REPORT TO CITY PLAN COMMISSION

Public Meeting Date: June 24, 2013

Item: Preliminary Plat/ Aspen Meadow

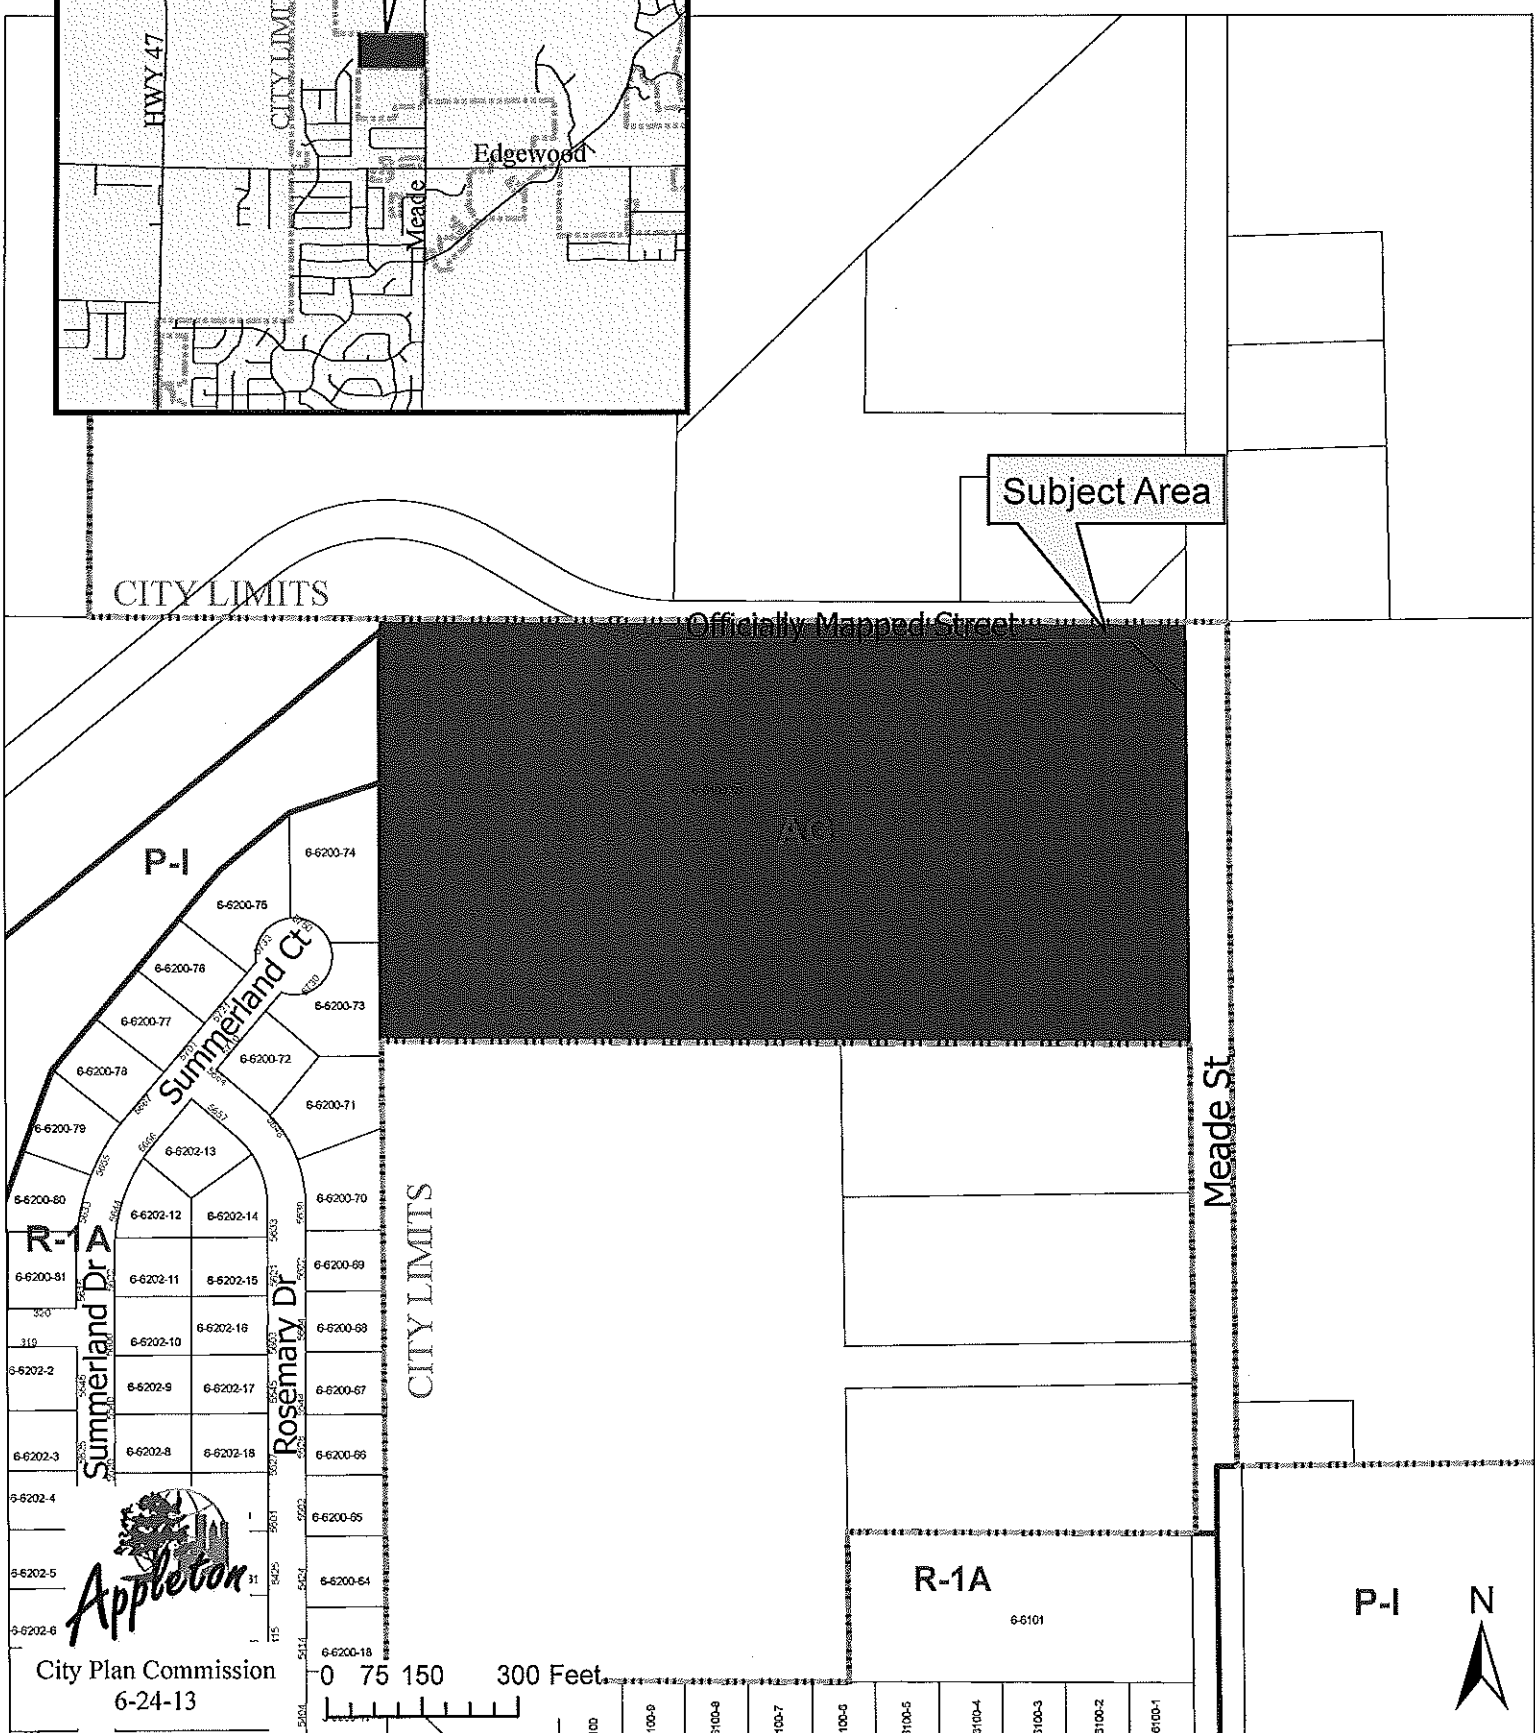
Based on the above, the Preliminary Plat for Aspen Meadow located on North Meade Street, as shown on the attached maps and subject to the following, **BE APPROVED:**

1. Rezoning of the property to R-1A Single-family residential must be approved by the Common Council prior to City signatures being affixed to the final plat.
2. The location of Officially Mapped Spartan Drive shall be revised to the correct location prior to approval of the final plat.
3. All stormwater management requirements must be met.
4. Park fees of \$300 per lot are due prior to the City signing the final plat.
5. The existing house shall be removed prior to a new single-family dwelling being constructed on Lot 5.
6. 17-17 (b)(4) Identify the location of abutting lot lines and names of any adjacent subdivisions, parks, cemeteries and unplatted lands.
7. 17-17 (b)(9) Identify corporate limit lines within the exterior boundaries of the plat or immediately adjacent thereto.
8. 17-17 (b)(6) and (11) All elevations shall be based on City datum.
